1 Comment

2 D2.3 (#111, #131, #181, #322, #214, #333, #369).

20 145.2.8.5.1 PSE PI pair-to-pair effective resistance and current unbalance

Figure 145A-1—Direct measurements of effective R_{PSE_max} and R_{PSE_min}

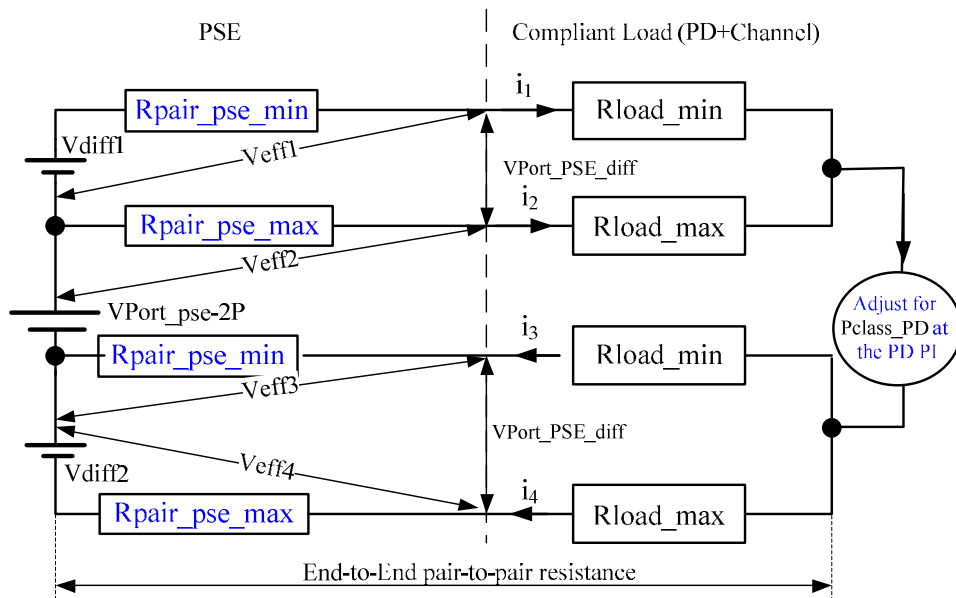
35 **Update Figure 145A-1as follows:**

36 **Change R_{pair_min} to R_{pair_pse_min}**

37 **Change R_{pair_max} to R_{pair_pse_max}**

Figure 145-34— I_{Con-2P} and $I_{Con-2P-unb}$ evaluation model

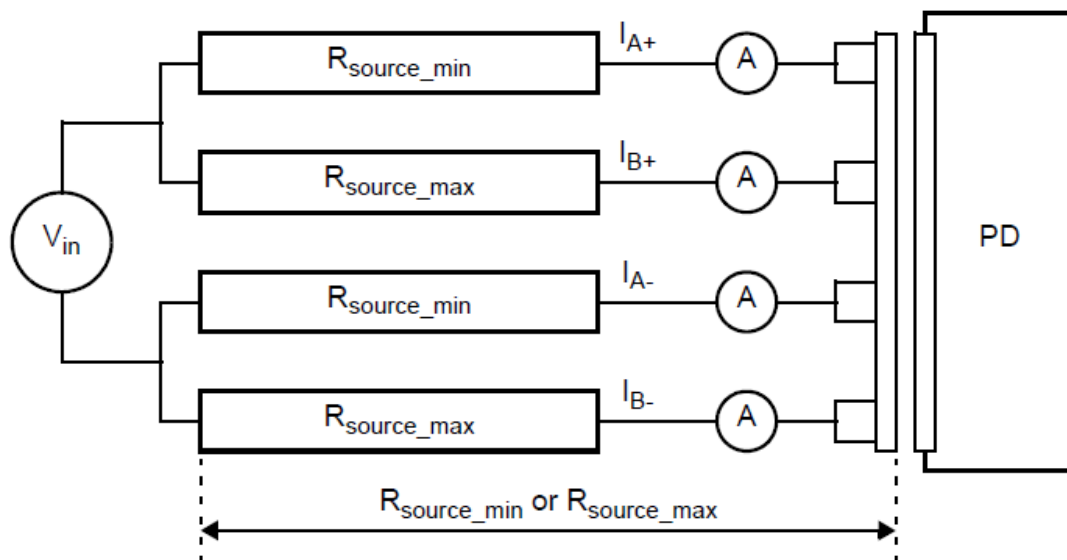
21 [\[Note 1 was changed to address comment #322. Note 2 cannot be changed\]](#)

22 NOTE 1—Rsource in Figure 145-34 includes ~~the connecting hardware resistance~~ ~~resistance~~ ~~Reon~~ ~~of~~
 23 ~~the evaluation model to the PD~~ which ~~its~~ ~~is~~ ~~the~~ ~~connection~~ ~~resistance~~ ~~at~~ ~~the~~ ~~PD~~. The maximum
 24 recommended ~~value~~ ~~is~~ ~~Reon~~ ~~value~~ is 0.02 Ω.

Figure 145X-1—PD resistance unbalance elements overview

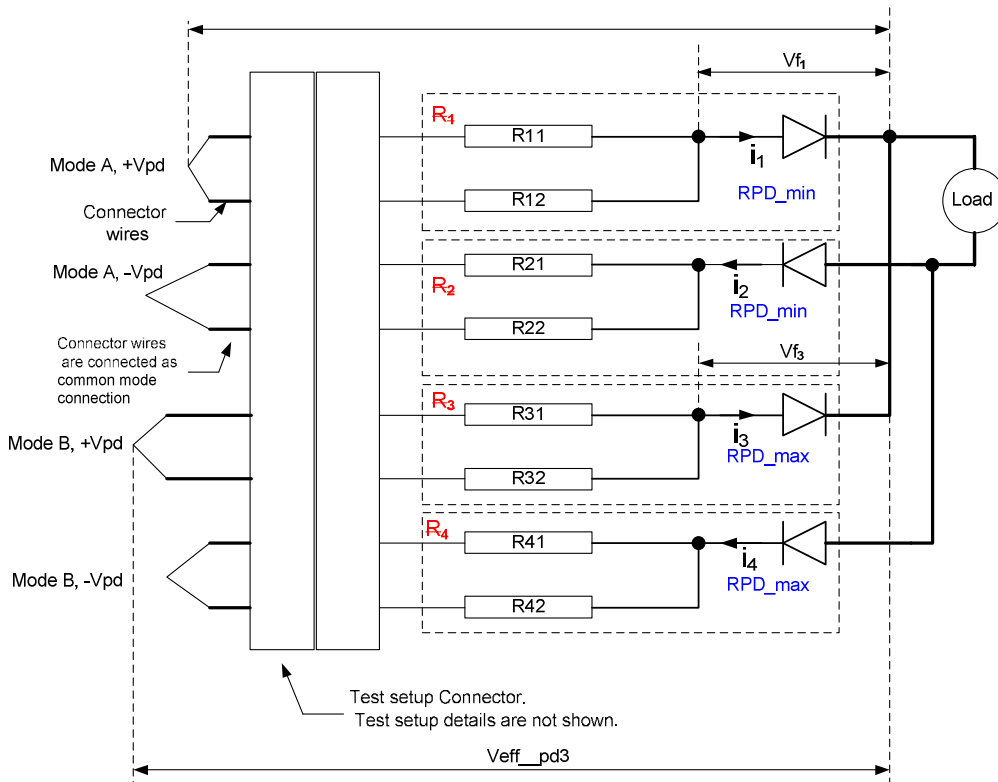
- Copy the following text and drawing into Annex 145X (used to be Annex 33A.5 in D2.2).
- Approved Changes in Figure 145X-1 from D2.2 to D2.3 are marked with RED color.
- New Changes in Figure 145X-1 from D2.3 to next draft are marked with BLUE color.
